## RECALL 17V-328: E65/E66 (7 SERIES) DOOR LATCHES

This Service Information bulletin supersedes SI B51 24 17 dated December 2017

The affected vehicles will be identified with the description: **0051170400 B51 24 17 Recall: Door Latches**

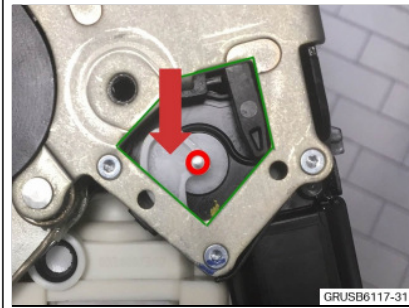
- Select the conversion "Conversion, Comfort Access without Electric Opening" and Program the vehicle with ISTA/P 3.63.3 (I-Level E065-17-11-520) or higher
- Remove and modify the 4 door latches

2. Once the door lock is removed, modify each lock by removing the white or yellow opening assist cam (red arrow).

3. Manually position the cam so that it is clearly visible in the opening.

4. Cut the head of the cam retainer off with a pair of cutters.

5. Slide the cam off and discard using a pair of needle nose vice grips.
